UNITED STATES
DEPARTMENT OF THE INTERIOR
BUREAU OF LAND MANAGEMENTFORM APPROVED
OMB NO. 1004-0137
Expires: January 31, 2018**SUNDRY NOTICES AND REPORTS ON WELLS**
Do not use this form for proposals to drill or to re-enter an abandoned well. Use form 3160-3 (APD) for such proposals.5. Lease Serial No.
NMNM06808

☒ Oil Well ☐ Gas Well ☐ Other8. Well Name and No.
JAMES RANCH UNIT DI 1A ENNIS 114H

Sundry to change name to James Ranch Unit DI 1A Ennis 114H, change SHL & BHL submitted on 4/30/20. WIS 513506

Conditions of Approval

Note: Picture below highlights BOP components that will be tested during batch operations

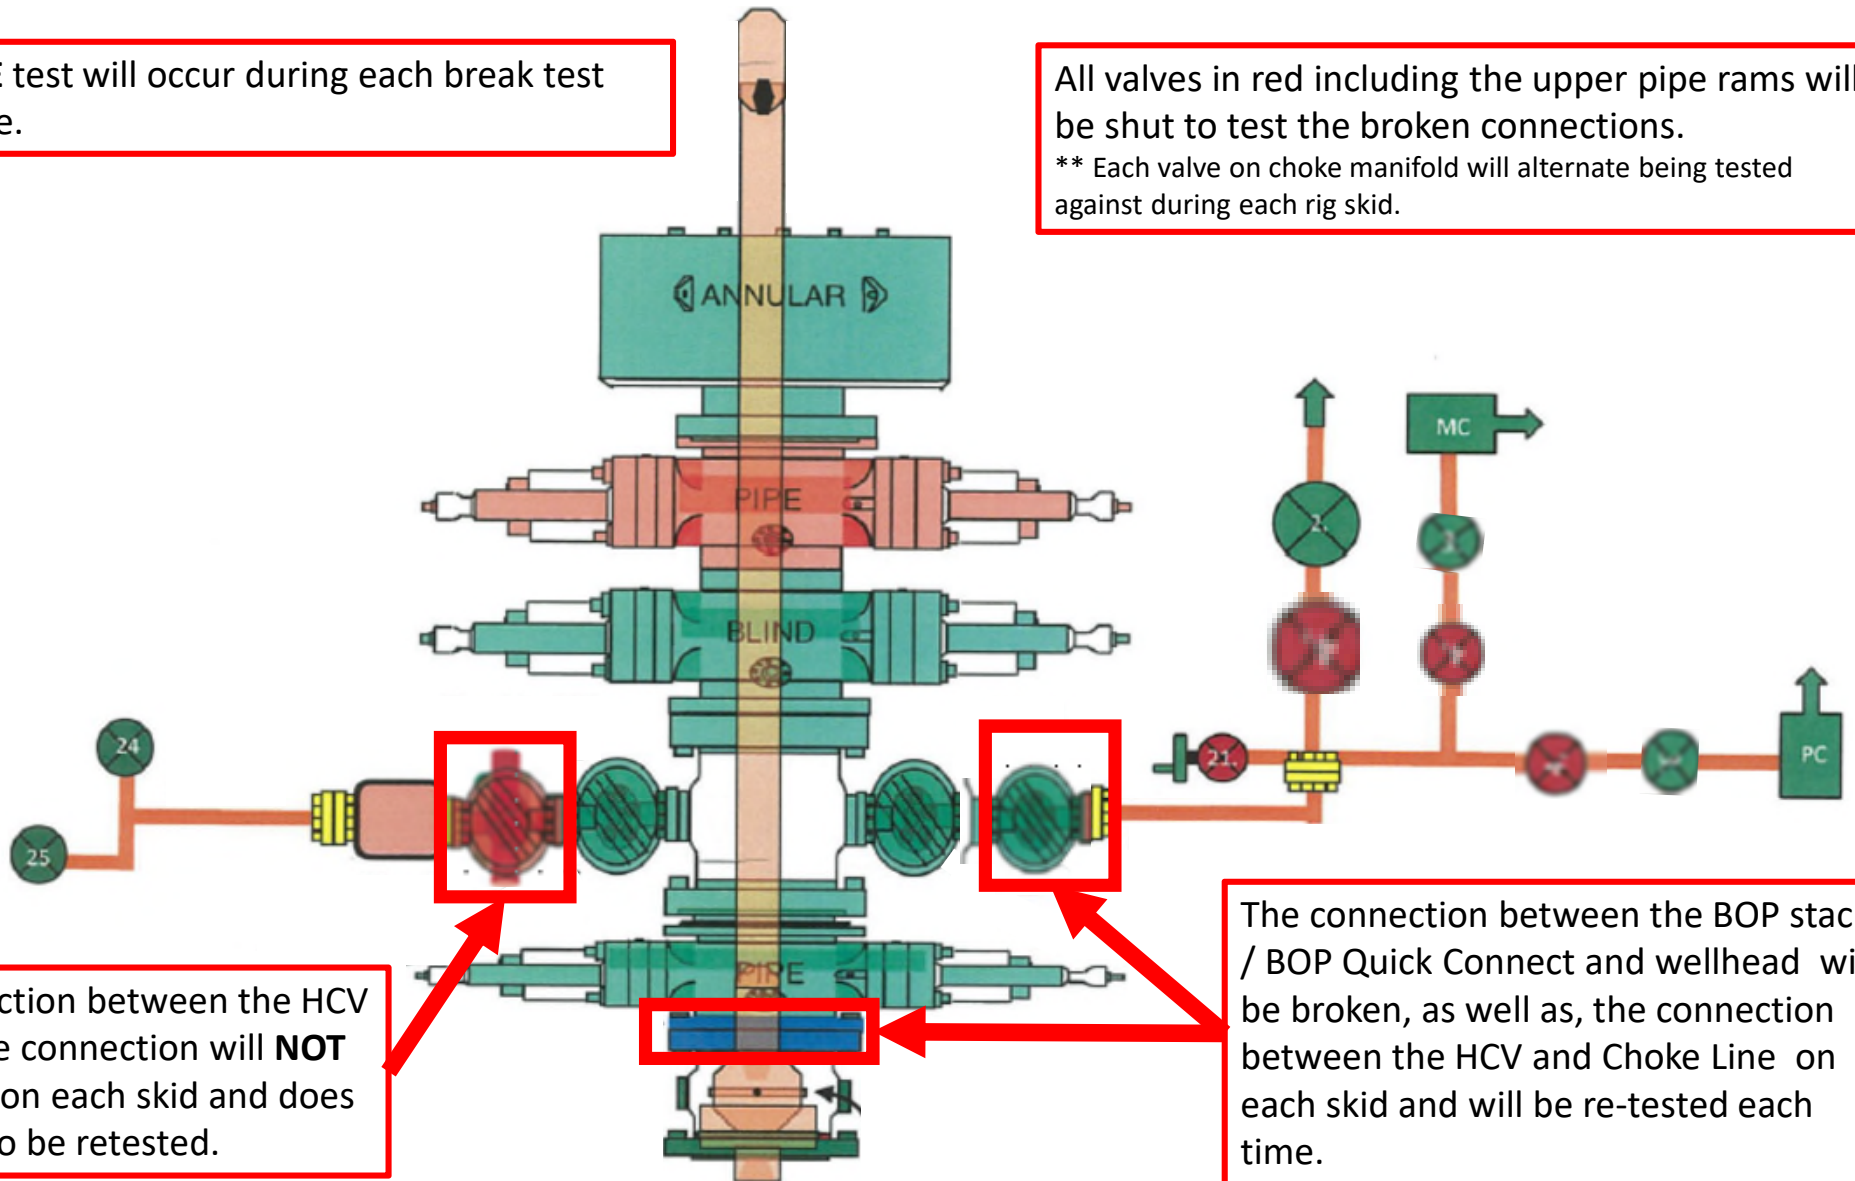
All valves in red including the upper pipe rams will be shut to test the broken connections.
** Each valve on choke manifold will alternate being tested against during each rig skid.

The connection between the HCV and kill line connection will **NOT** be broken on each skid and does not need to be retested.

The connection between the BOP stack / BOP Quick Connect and wellhead will be broken, as well as, the connection between the HCV and Choke Line on each skid and will be re-tested each time.

BOP Break Testing Variance Shell testing is not approved for any portion of the hole with a MASP of 5000 psi or greater

- While in transfer between wells, the BOPE shall be secured by the hydraulic carrier or cradle.
- Any well control event while drilling require notification to the BLM Petroleum Engineer prior to the commencement of any BOP Break Testing operations.

A full BOP test is required prior to drilling the first deep intermediate hole section. If any subsequent hole interval is deeper than the first, a full BOP test will be required.
